Groundwater Remedy Construction, PG&E Topock Compressor Station, Needles, California

Work Variance Request #10 – Revised Alignment for Pipelines C18 (East Ravine) and I1 (Bat Cave Wash), and Consolidation of Pipes/Conduits in the Southernmost Area of TCS

Date Submitted: 12/1/21

Variance Request No.: 10

**WORK VARIANCE REQUEST #10 - PROPOSED REVISED
ALIGNMENT FOR PIPELINE C18 (EAST RAVINE), PAGE 1 of 2**

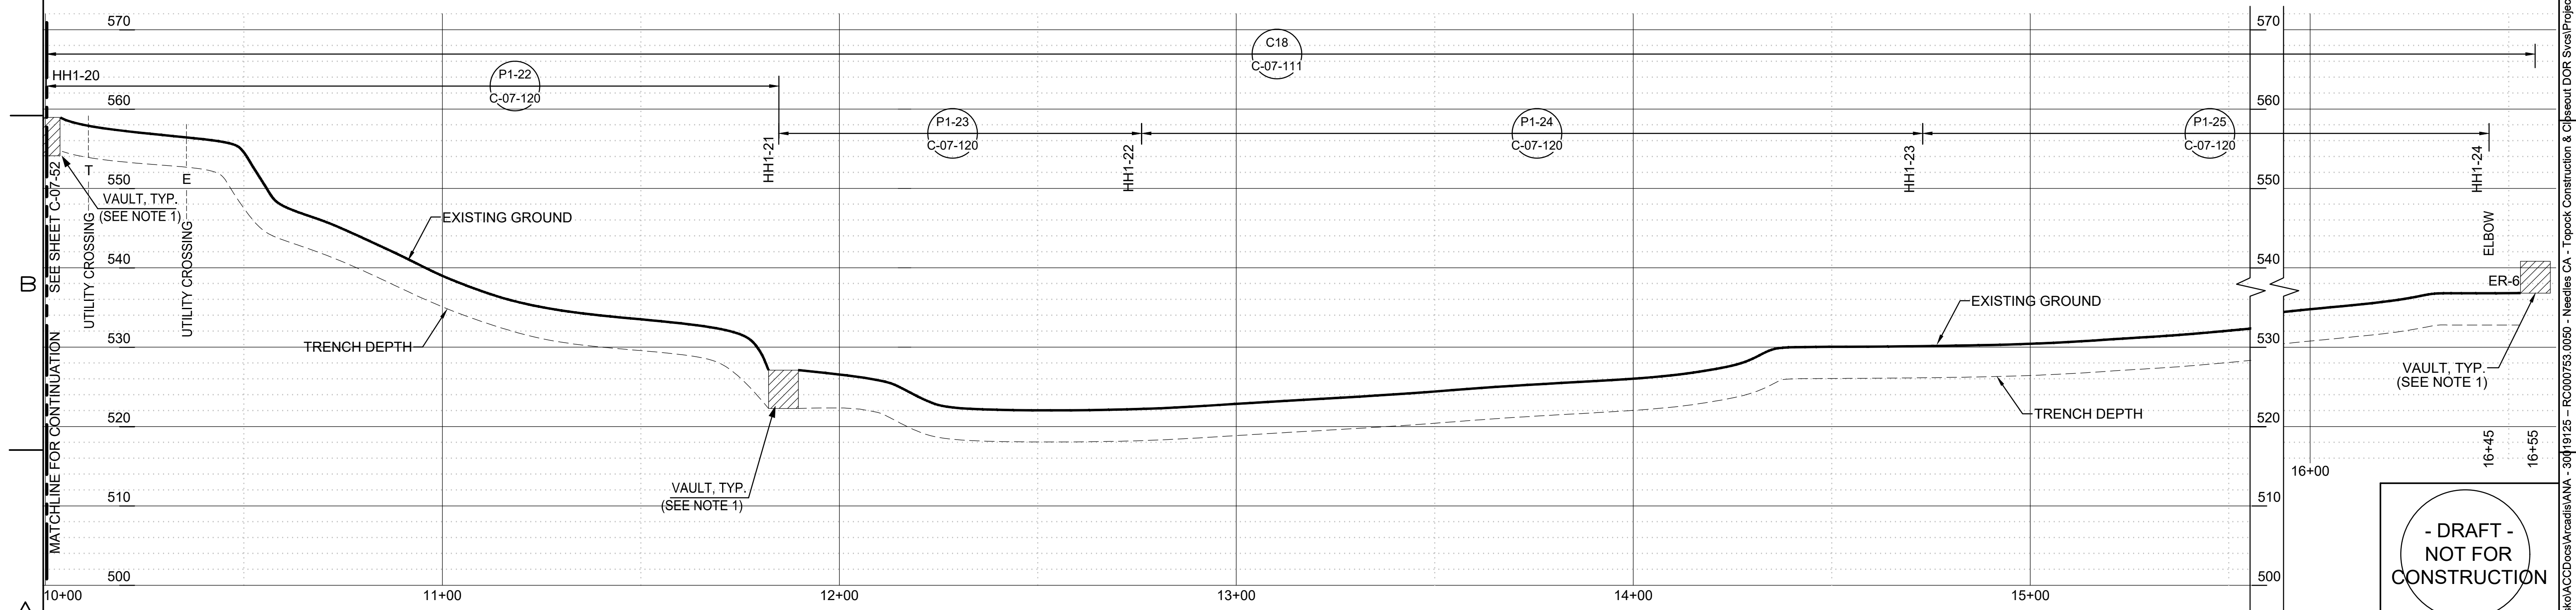
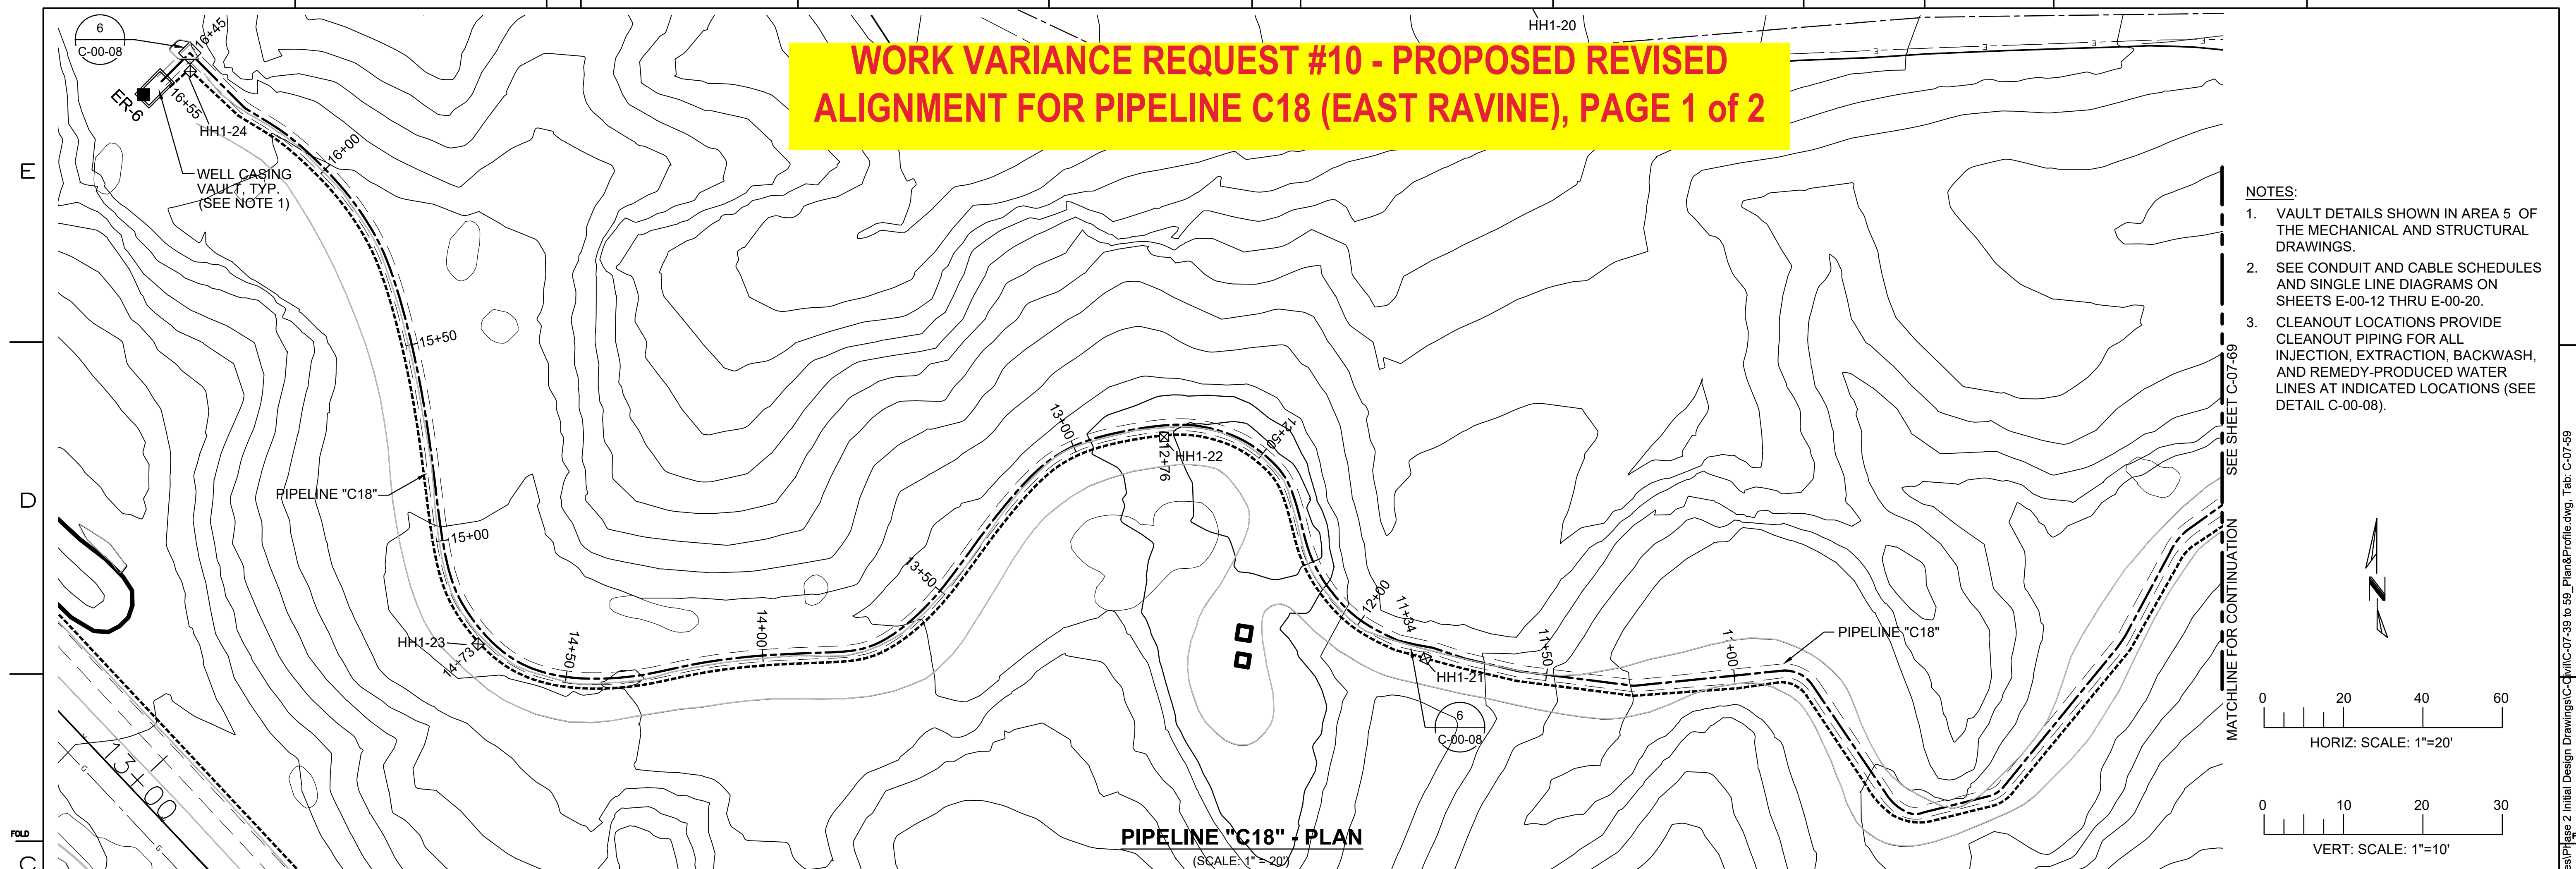
Revise the alignment of Pipeline C18 in the East Ravine – The revised alignment is necessary for connection to the revised Pipeline F alignment (approved by agencies in May 2019 and constructed in Phase 1). The revised alignment eliminated the portion of C18 located on the steep northern slope of the East Ravine, and instead routed pipes/conduits to the east, along the existing access route in the East Ravine. The estimated net change in the excavated soil volumes and pipelines/conduits/trench lengths are:

1. Soil disturbance: an increase of 131 cubic yards.
2. Linear footage of liquid conveyance piping/conduits: an increase of 944 feet.
3. Linear footage of trench: an increase of 236 feet.

WORK VARIANCE REQUEST #10 - PROPOSED REVISED ALIGNMENT FOR PIPELINE I1 (BAT CAVE WASH)

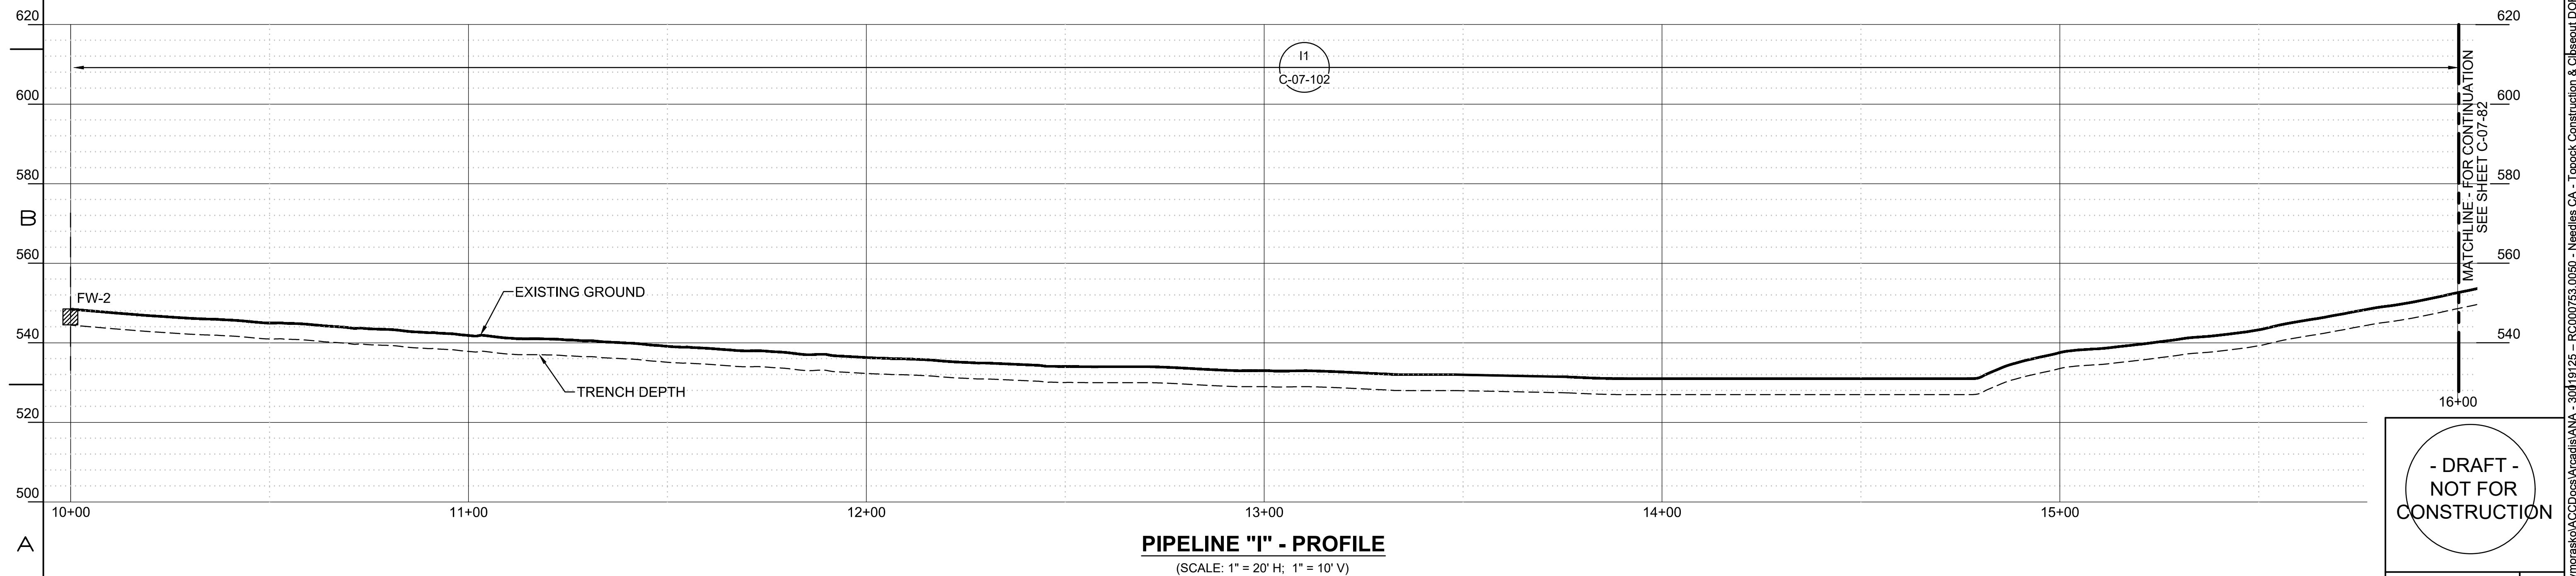
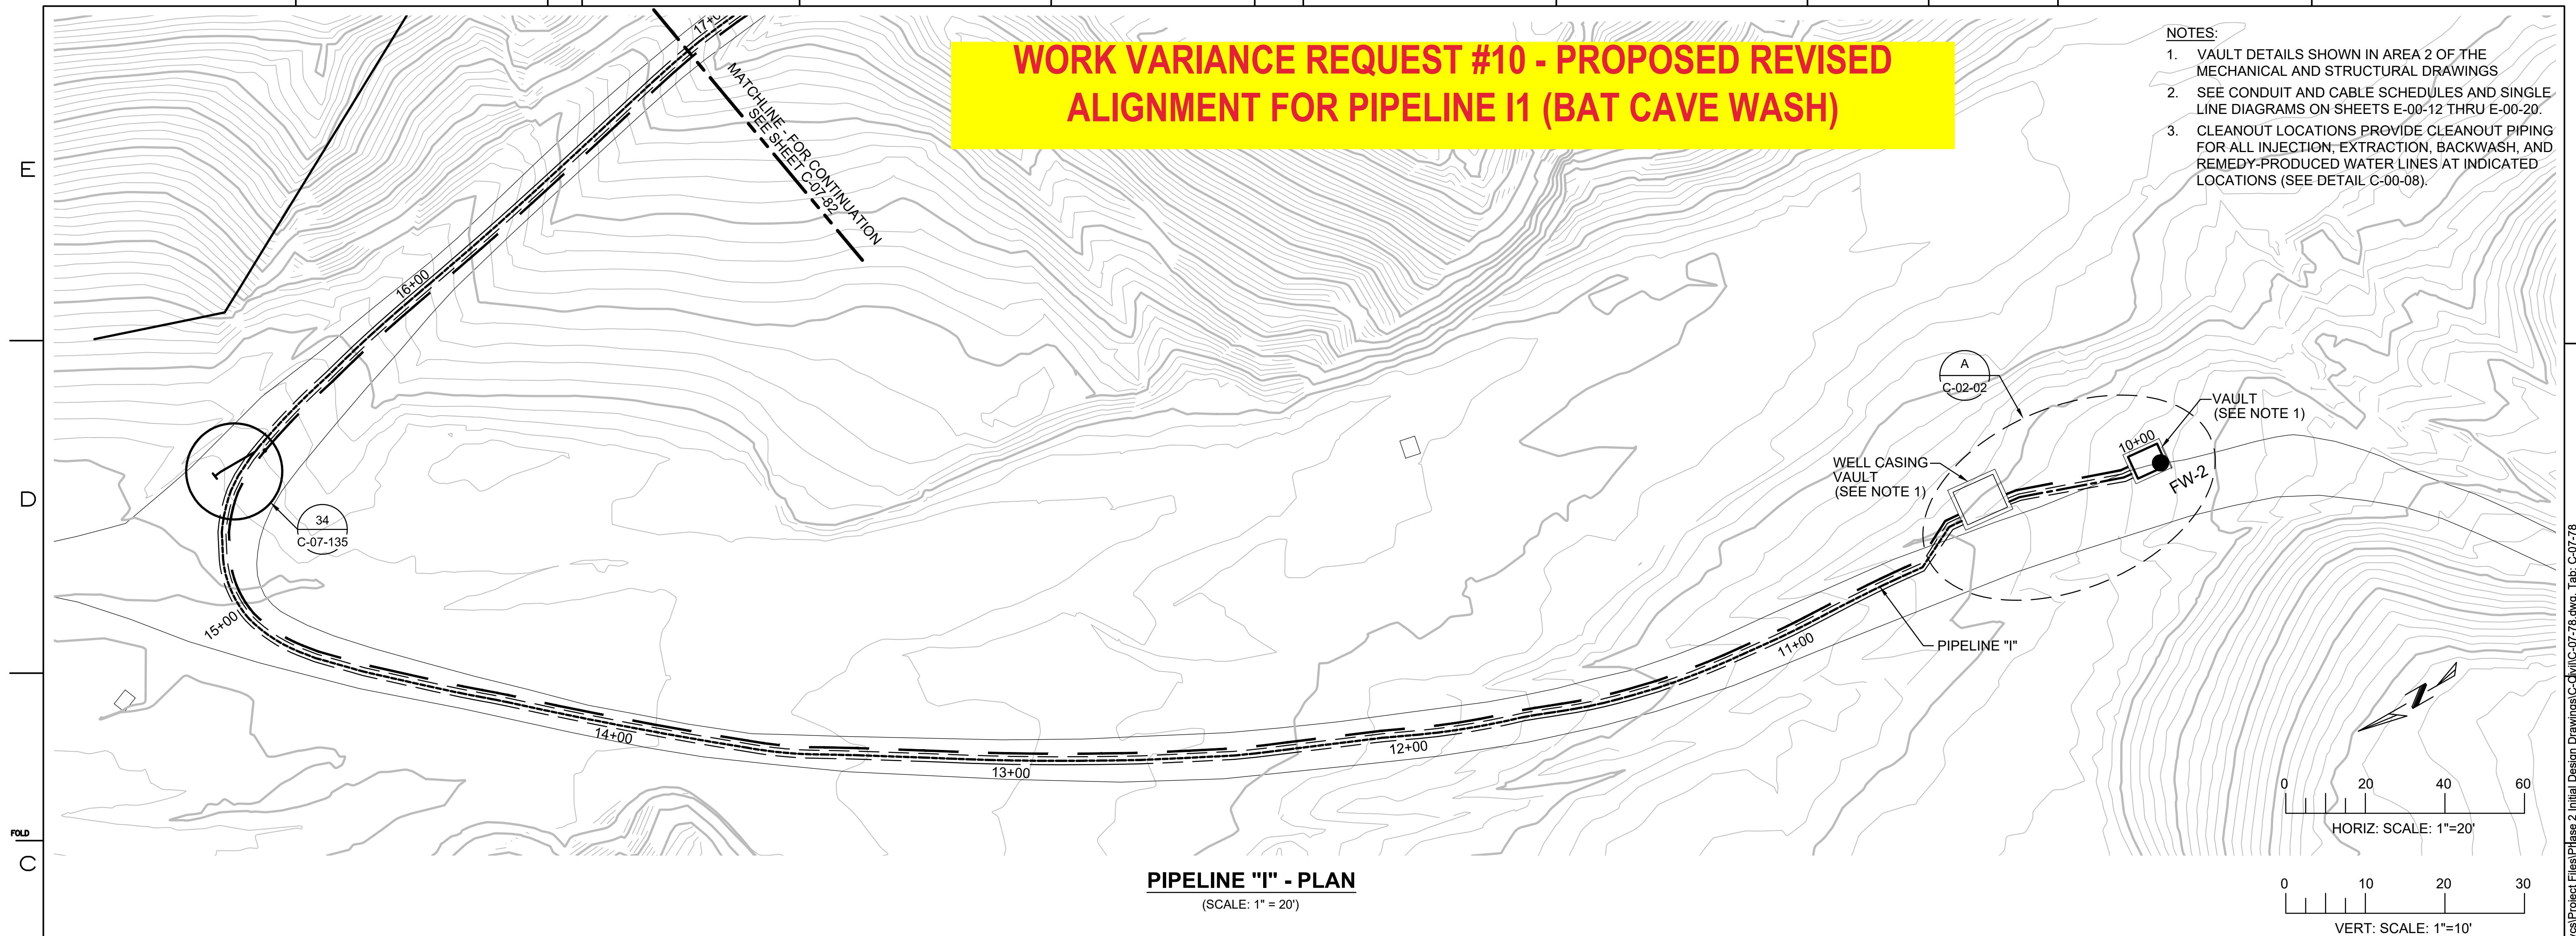
Revise the alignment of Pipeline I1 in Bat Cave Wash – This revised alignment moves portion of Pipeline I1 that is on an unimproved area west of the access road to Bat Cave Wash onto the access road. This revision improves pipeline constructability and minimizes vegetation removal during construction. In addition, it will minimize disturbance during future pipeline maintenance activities. The estimated net change in the excavated soil volumes and pipelines/conduits/trench lengths are:

4. Soil disturbance: an increase of 74 cubic yards.
5. Linear footage of liquid conveyance piping/conduits: an increase of 1,072 feet.
6. Linear footage of trench: an increase of 134 feet.
